Table of Responses to Public Comments on Draft NUREG-2195

Calvert Cliffs CSGTR Supplemental Plots for Responses to Public Comments

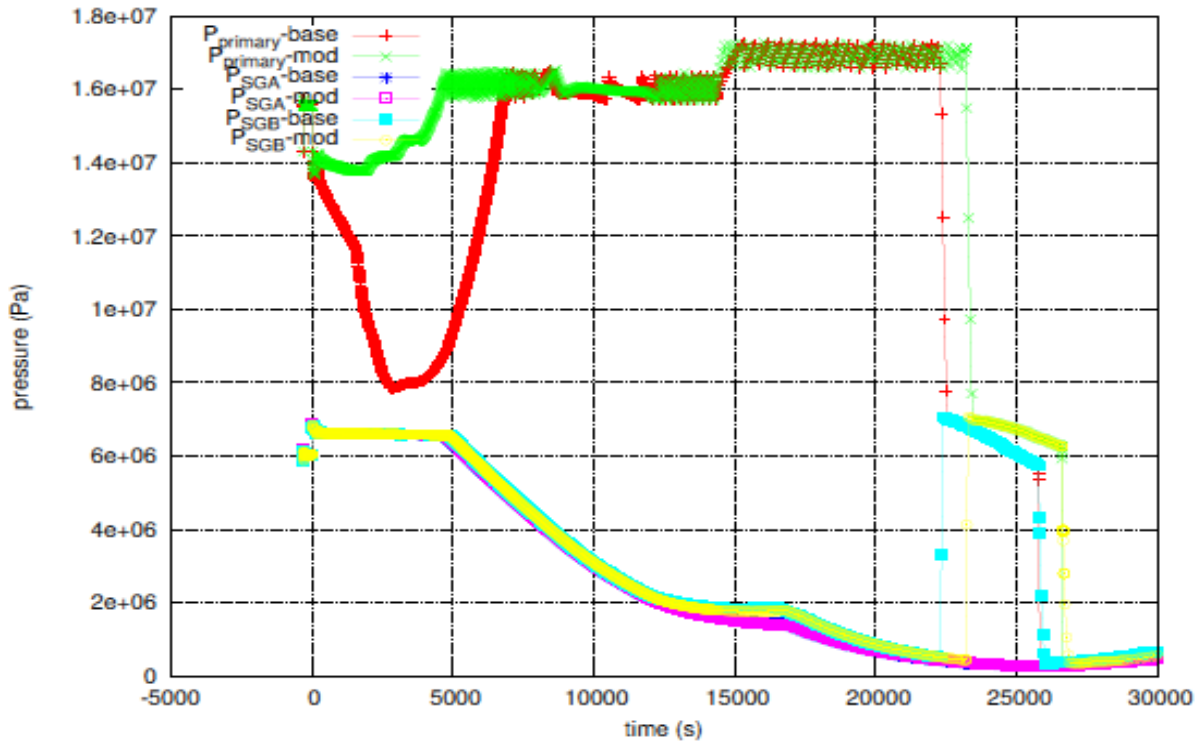
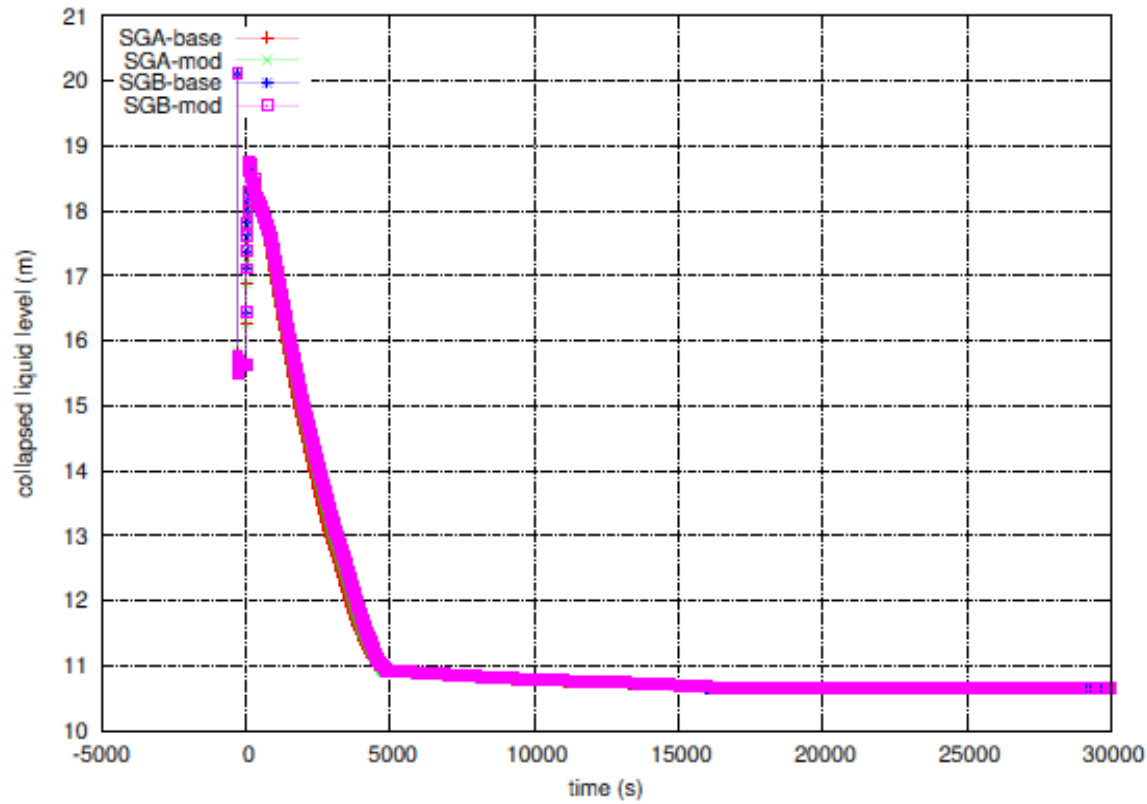
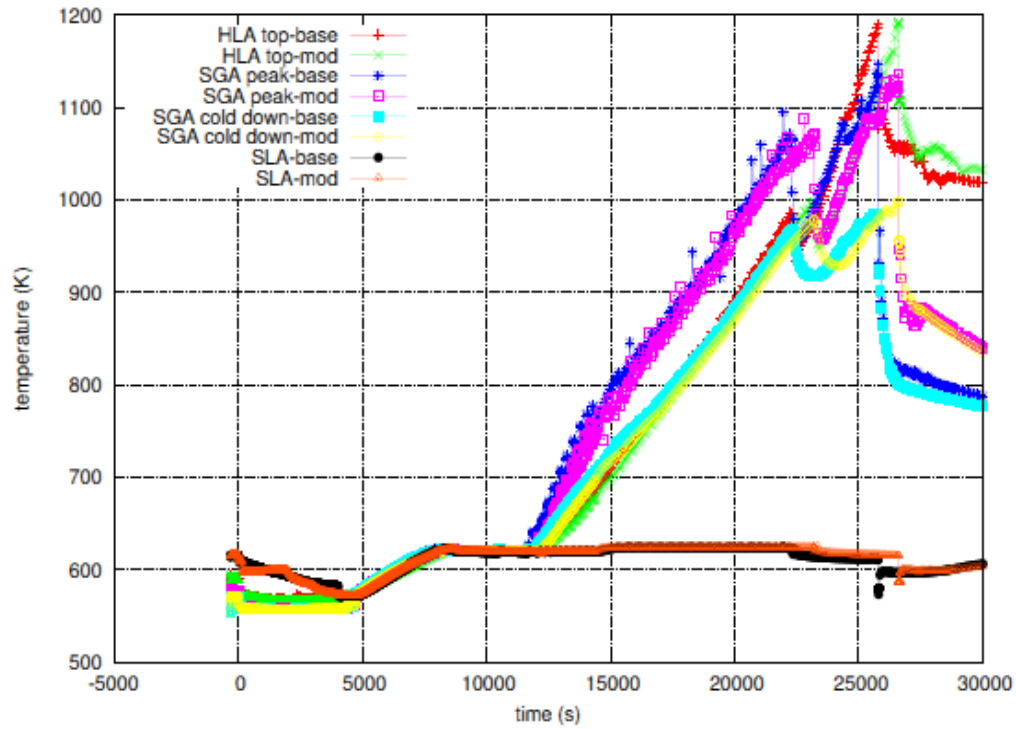
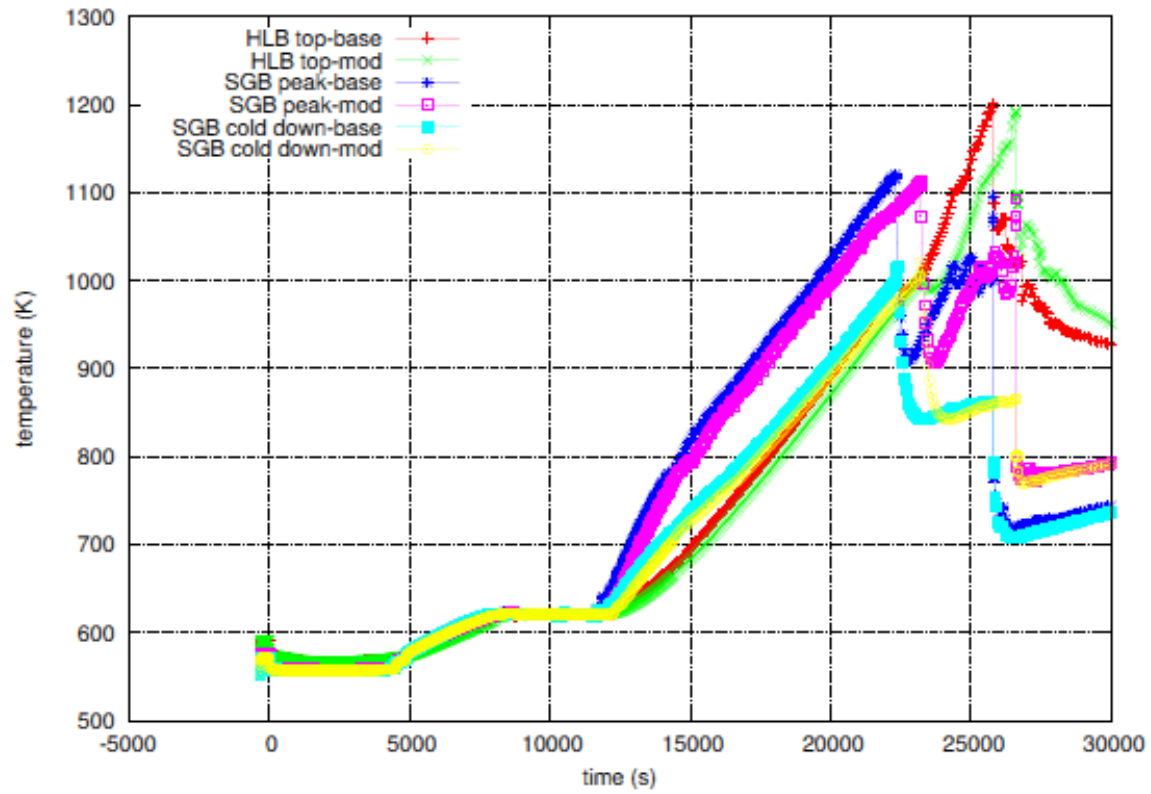
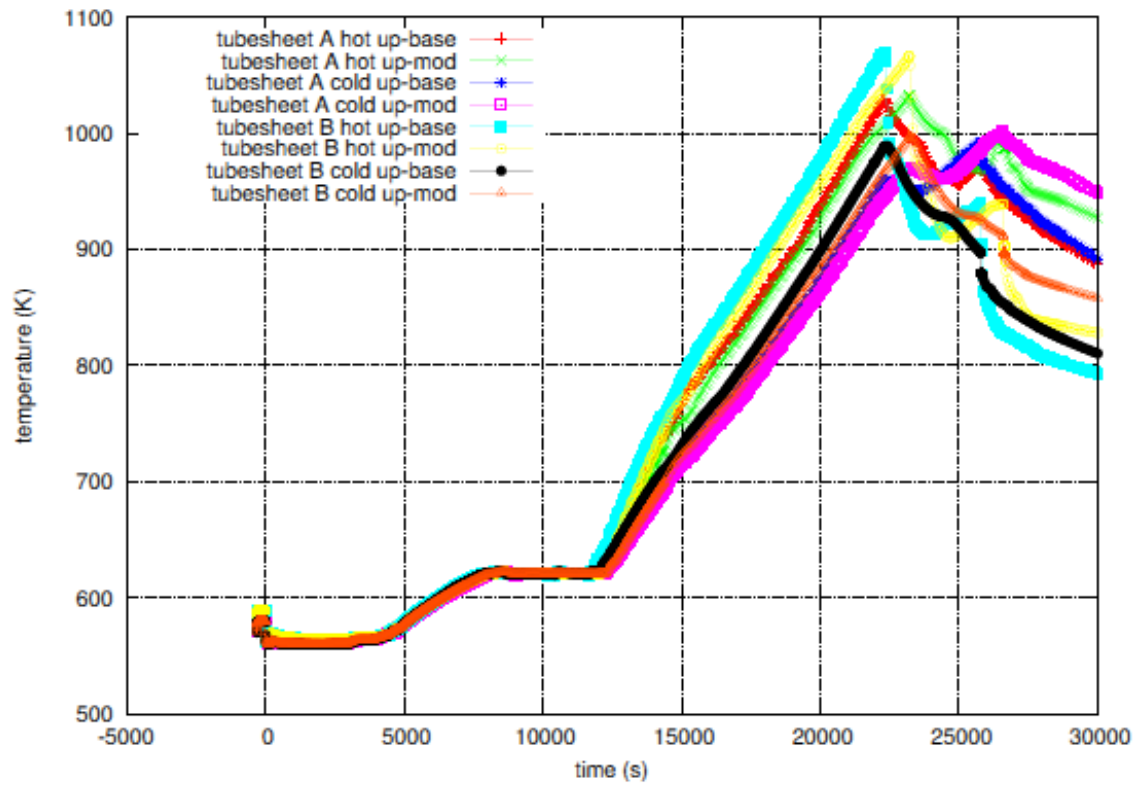
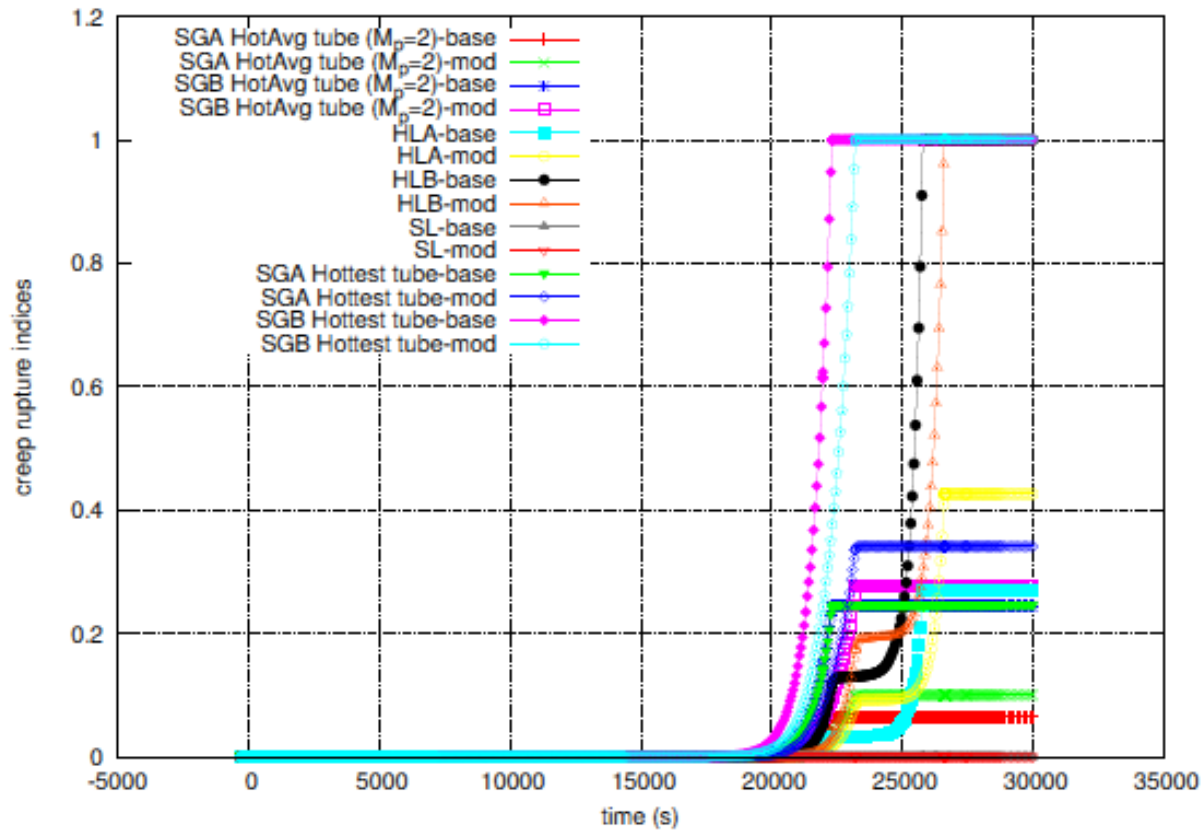
FYNAN Public Comment	RES Response	PUT IN NUREG?
	<p>primary side steam as it flows through the SG tubes are governed by this slow SG depressurization. The heating rate of the SG tubes may also be coupled to the SG secondary side depressurization. A primary side flow rate of 0(10) kg/s being cooled 100 deg C can raise the temperature of secondary side steam mass of 0(10³) kg by approximately 1 deg C/s. These are some of the subtleties that should be considered when comparing the base cases with other sequences with different secondary side depressurization assumptions.</p>		
5	<p>Comment 5 (Page 2-12, line 3): What is the technical basis for assuming 21 gpm per pump RCP seal leakage? Are these plant specific/installed pump seal package values or just assumptions? What is the effective leak path area modeled to obtain 21 gpm at operating RCS pressures? For all analyzed sequences in Chapters 3 and 7, it would be helpful to see a plot of the integrated mass flow through the pump seal leaks as a function of time compared to integrated mass flows through the pressurizer PORVs and SRVs. For the past 25 years, much time and effort has been spent in the severe accident simulation community agonizing over pump seal leakage modeling and many NUREG and topical reports have sections or chapters dedicated to the topic. However, it remains unclear whether the small mass and enthalpy flow rates through modeled nominal RCP seal leaks actually matter to any of the severe accident phenomena of interest in these studies.</p>	<p>The 21 gpm pump seal leakage is typical of a Westinghouse plant without SHIELD^{®2}. CE plants with Flowserve or similar seals and Westinghouse plants with SHIELD[®] mechanical seals or Flowserve pumps or CE plants have very low leakages following SBOs (generally less than 2 gpm). The 21 gpm nominal seal leakage per RCP was assumed for the CE plant just for consistency with the Westinghouse plant.</p> <p>Additional MELCOR run was performed assuming no RCP leakage for the CE plant. The analysis indicated that even the small amount of seal leakage will impact the rate of early depressurization, the heat up rate will shift in time, but the conclusions regarding C-SGTR probability is not expected to be significantly changed.</p> <p>In response to another comment a simulation was rerun assuming no RCP seal leakage.</p>	Y

FYNAN Public Comment	RES Response	PUT IN NUREG?
		See response to question A.2.1. A plot of integrated mass flow through RCP seal leak for the stsbo case is provided in the attached document (Attachment A).	
6	Comment 6 (Page 2-15, line 29-41): Is the discussion in this paragraph conjecture or has technical work or simulations been performed to support these statements? To clarify, this paragraph appears to be discussing the blow down of the high pressure RCS through SG tube breaks to the low pressure SG secondary side. The collapse of the countercurrent flow regime in the RCS primary side would be analogous to the temporary breakdown of the countercurrent flow when the pressurizer PORV or SRVs cycle. Is the conclusion of this paragraph that guillotine break of three tubes causes the blow down of the RCS that disrupts the countercurrent natural circulation flow? In lines 31-33, would such a blowdown event depressurize the RCS such that the accumulators inject possibly arresting core melt?	The discussion referred to by this comment was based on simplified analysis and it was originally intended for detailed Level 2 PRA evaluation. It is nor more pertinent to this study and it is therefore removed. The report was modified to reflect that. Regarding the primary depressurization as a result of the guillotine break of one tube, we do not expect that such a blow down event depressurize the RCS such that it results in accumulator injection. Section 7.1.6 of the report discusses that such a small leakage will not depressurize the primary such that accumulator/SIT injects unless additional tubes are failed.	Y 1. Text was deleted. 2. Ref.4 was removed and other ref. numbers were changed, 3. Noted there are no references made in the text for Ref. 5 and 6. They were removed.

Fig. 9: stsbo decay and oxidation power contribution

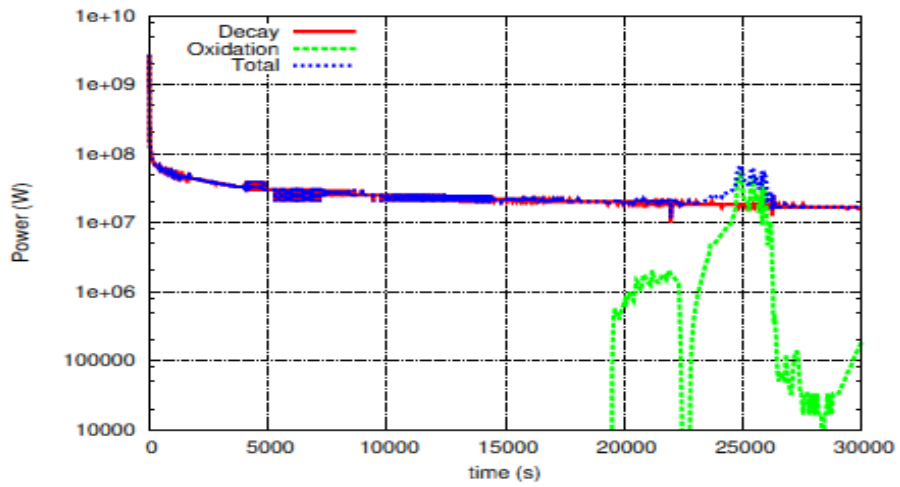
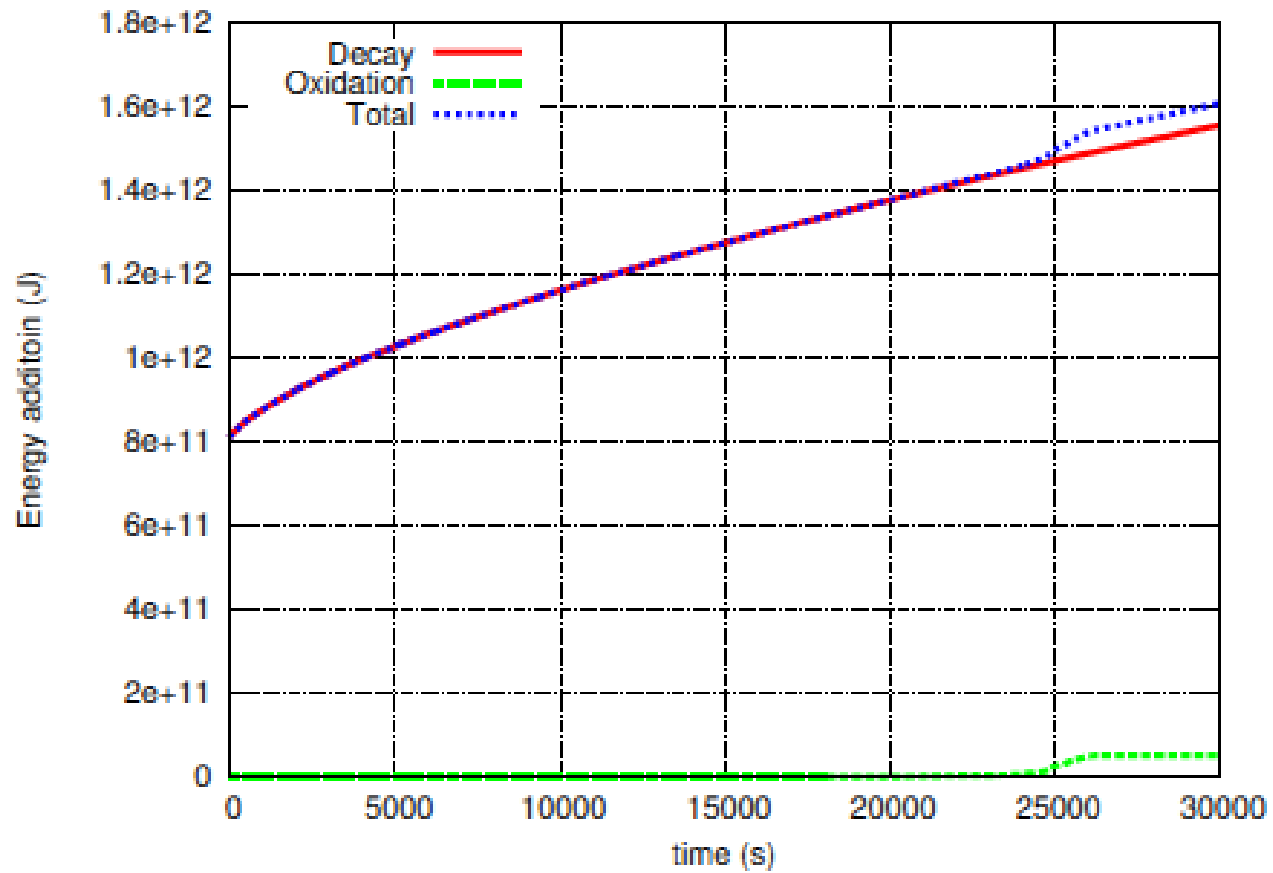
FYNAN Public Comment	RES Response	PUT IN NUREG?
	Quantify the statement "a little slower". This is a very significant result. Although the heatup of RCS components is occurring at very different absolute times (over 6 hours difference) the <i>heatup rates</i> are approximately the same.	3-18. The stsbo and ltsbo sequences seem to be very similar – just time shifted. The average temperature rise for the hottest tube for stsbo-a was 0.58 K/s with a faster temperature rise of .078 K/s over approximately 2000 s and 0.052 K/s afterwards. For the ltsbo-a the average temperature rise for the hottest tube was 0.049 K/s. The faster rate was not as significant for the ltsbo case: ~0.55 K/s before and 0.48 K/s after the inflection. Note that these changed fluctuate somewhat with time and that the calculated rates depend somewhat on the bounds chosen for their evaluation.	
20	Comment 20: (Page 3-42, line 40) See comment 17: show power from water metal reactions as function of time.	Plots of the decay and oxidation energies and powers and energies are provided in the attached document (Attachment A).

Fig. 11: Comparison of upper hot leg B velocities for different hot-leg natural circulation models

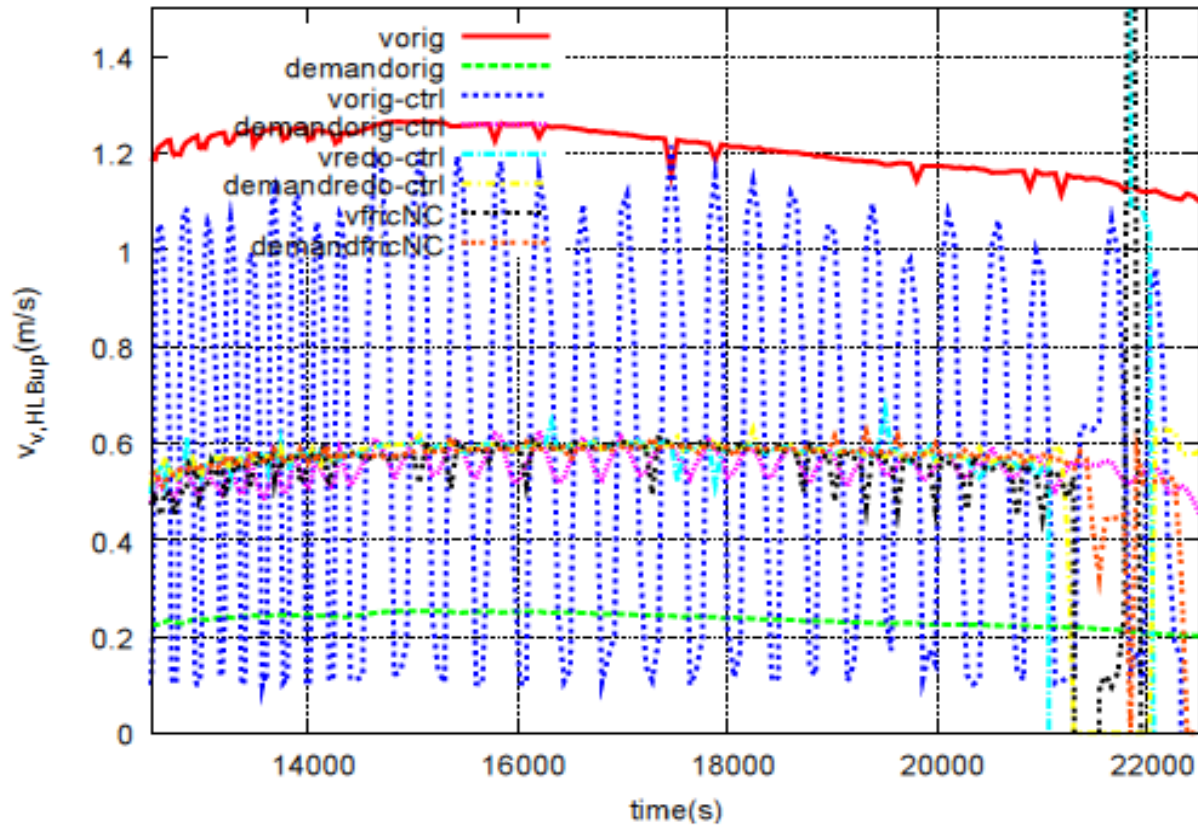
FYNAN Public Comment	RES Response	PUT IN NUREG?
		<p>one can approximate the pressure drop.</p> <p>The velocity for each segment was approximately ½ m/s for a differential velocity, and differential velocity squared, of about 1.</p> <p>The density varied with increasing temperature but was in the range of 50 kg/m³.</p> <p>So the differential pressures resulting from the countercurrent flows were approximately in the range of:</p> $dP \sim 1.875 \times 50 \text{ [kg m}^{-3}\text{]} \times (1) \text{ [m}^2 \text{ s}^{-2}\text{]} \sim 94 \text{ Pa}$	
14	<p>Comment 14 (Page 3-19, lines 34-35): Please quantify the statement "...were found to be higher than those of Fluent". Why do higher (and quantify how much higher) hot-leg velocities prefer tube over HL failure? Do heat transfer coefficients and residence time change as a function of velocity? See comment 1: the result of different heat transfer coefficients and residence time can be observed in the heatup rates.</p>	<p>It was a significant fraction- some tens of percent. The specific amount was never quantified because it represented an intermediate stage in the deck development process.</p> <p>Note that this relates to the modeling described in your questions 12 and 13. As mentioned in those responses user-added models set the HL velocities. The fact that the velocity was off just indicates that the user-added model wasn't calibrated and does not reflect something inherent to the MELCOR code.</p> <p>No specific higher velocity threshold that prefers tube failure over HL is expected. The expectation that higher</p>	N

FYNAN Public Comment	RES Response	PUT IN NUREG?
		<p>velocities favor SG failure results from the following general reasoning: the temperature drop over the HL is less at higher velocities resulting in a slightly higher temperature of gas entering the tubes. Since not much cooling occurs this effect is not expected to be large.</p> <p>Both heat transfer coefficients and residence time do indeed depend on velocity.</p>	
15	<p>Comment 15 (Page 3-20, line 32): This behavior <i>is</i> scenario dependent. Most of the cases presented later in Ch. 3 assume the 0.5 in² secondary leakage which also controls secondary depressurization after TI-SGTR and RCS blowdown to the secondary side. See Figure 3-5 on page 3-26 from 23000 seconds to 26000 seconds. If the initial depressurization is modeled as an opened ADV, the release to the environment will be much greater.</p>	<p>Yes, fission product releases would differ for open relief valve scenarios.</p> <p>The statement in the document referred to whether or not releases would occur in different closed-secondary-relief-valve scenarios.</p>	N
